April 30, 2015

**Re: Notice of Alteration for the Tyndal Transmission Project (Environment Act License No. 3103)**

**DETAIL 2**  
SCALE: N.T.S.

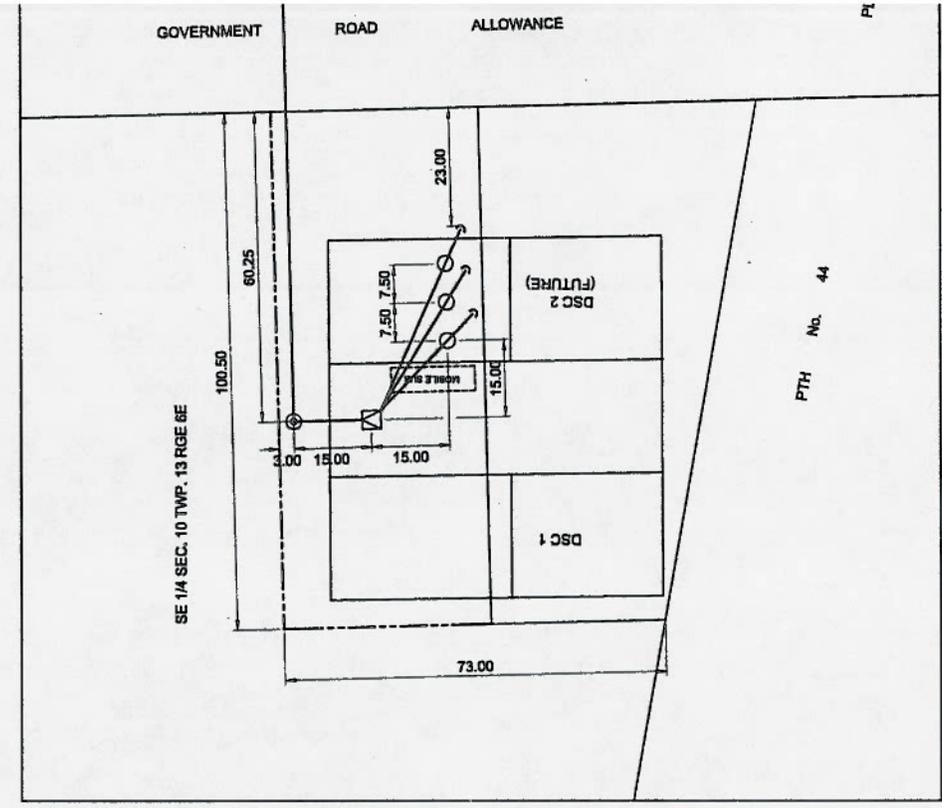
- 2) In February of 2014 (after submission of the EAPF but prior to receiving a license) Manitoba Hydro submitted a notice of alteration (attached). The proposed alteration was to move from the rail bed and cross over farm land then follow along a municipal road. At this point in time, Manitoba Hydro has chosen to revert back to the original preferred route along the rail bed.

- The proposed change should have an overall net benefit (other than slight increased cost to hydro). The change will remove the route from two properties, both of which are active farm land. The route will be shorter (~400 m) and follow along an old municipally owned rail bed (some recreational activity and minimal wildlife habitat).

**DETAIL 1**  
SCALE: N.T.S.

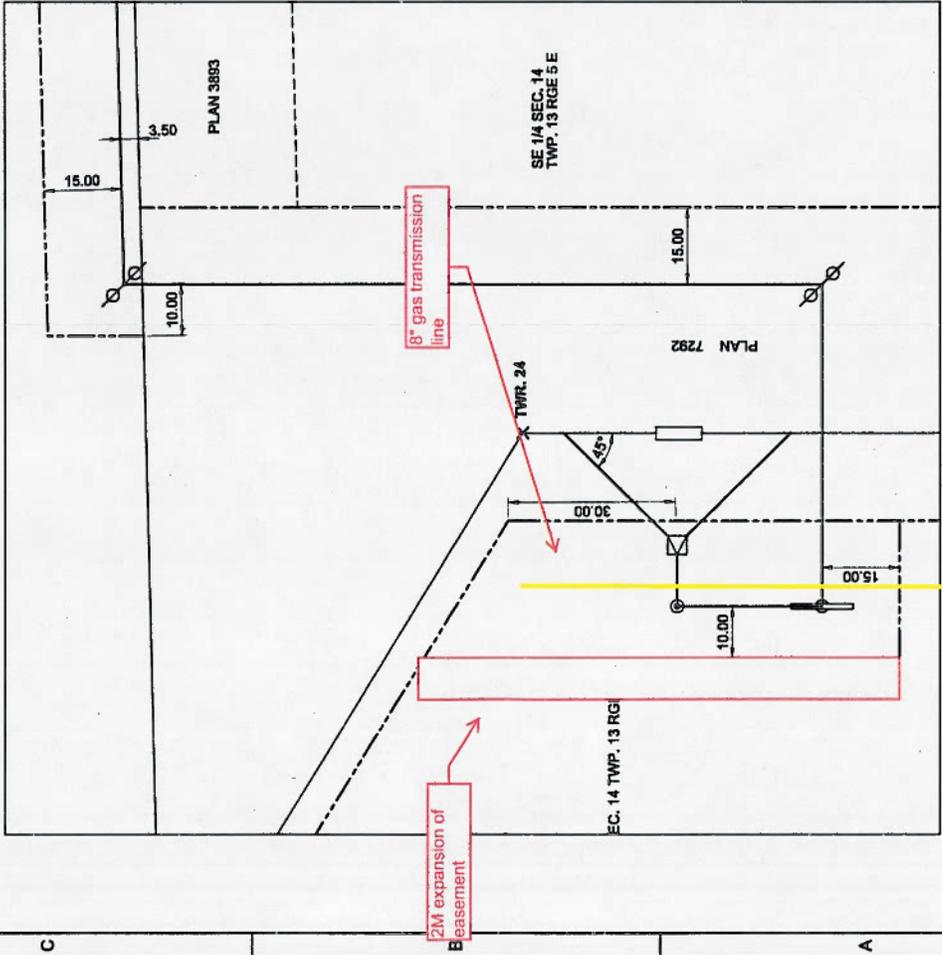
- 1) Manitoba Hydro is moving two towers 10 m to the west to give clearance to an 8" high pressure gas transmission line at the tap location. This will require a 2 m extension on the west side of the existing easement (already secured). See detail 1 on the attached drawing.

- The proposed change should not alter potential project affects as the footprint does not change and it remains on farm land and the same property owner.
